JAFNPP  
TABLE 3.2.1 3.3.6.1-1

**PRIMARY CONTAINMENT ISOLATION SYSTEM INSTRUMENTATION  
TEST AND CALIBRATION REQUIREMENTS**

Amendment No. 77, 80, 126, 141, 142, 140, 207, 227

FIG. ~~3.1.7-1~~ 3.1.7-1  
 SODIUM PENTABORATE SOLUTION (MINIMUM 34.7 B-10 ATOM% ENRICHED)  
 VOLUME CONCENTRATION REQUIREMENTS.

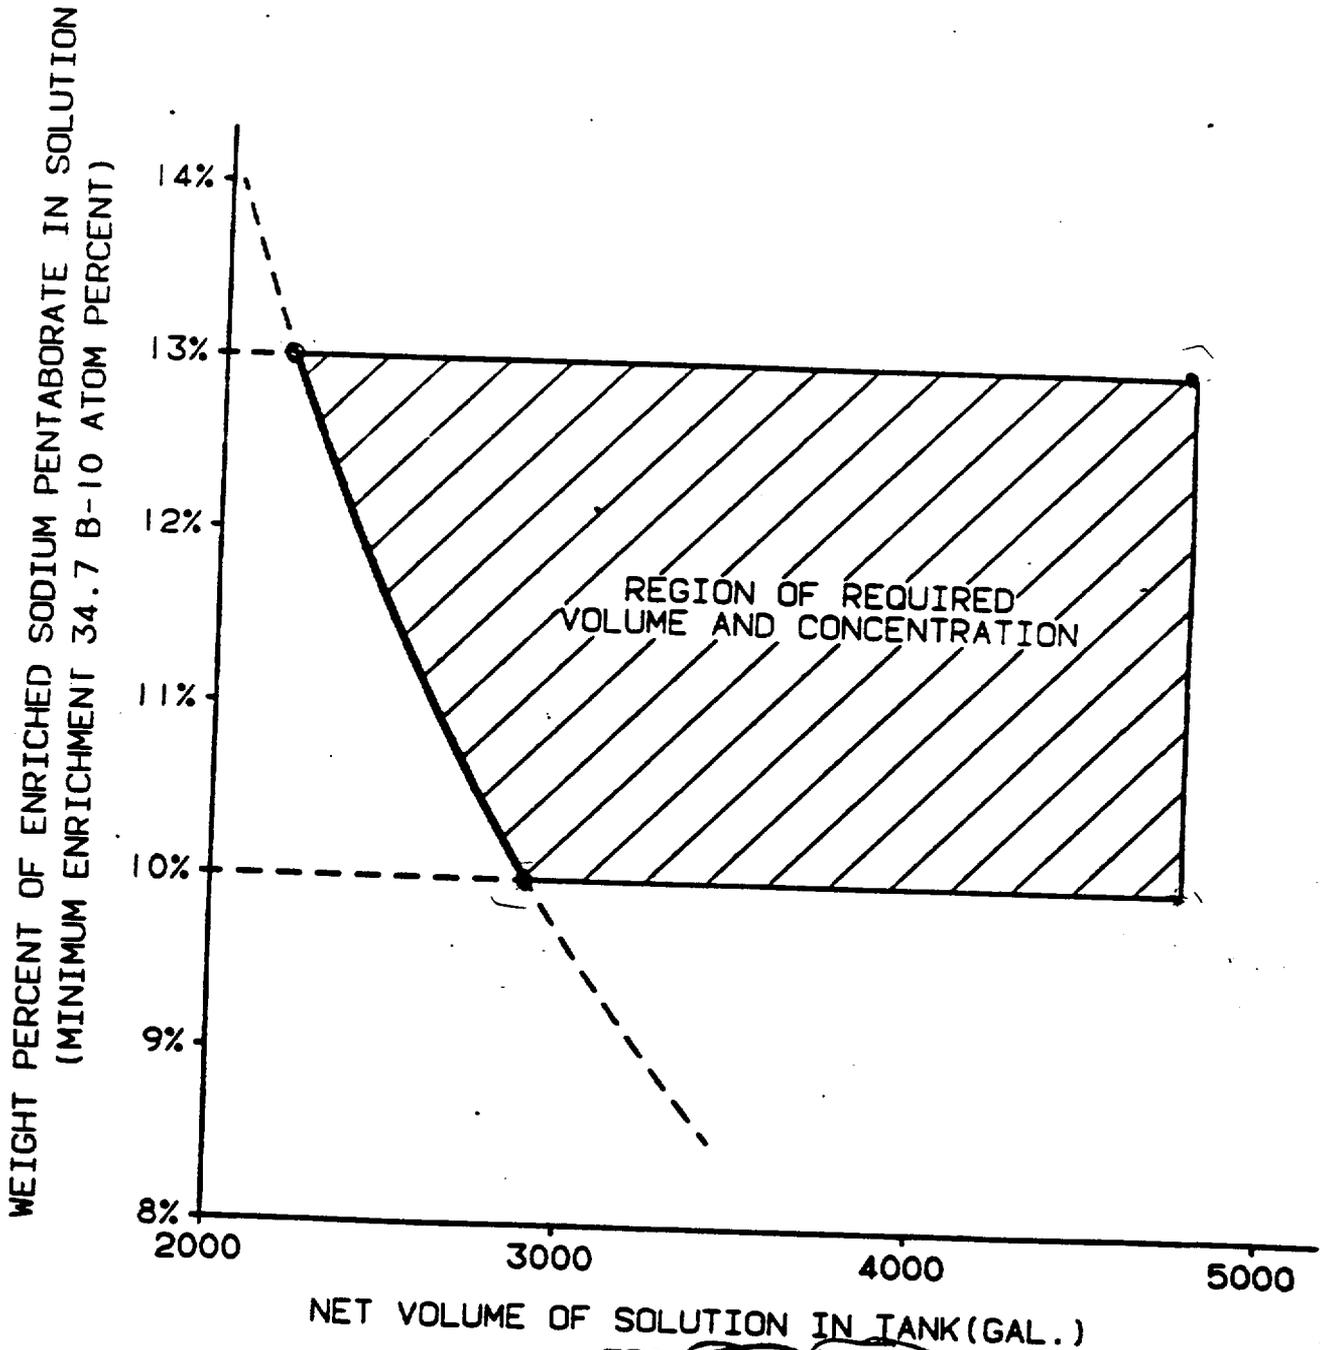
[M4]
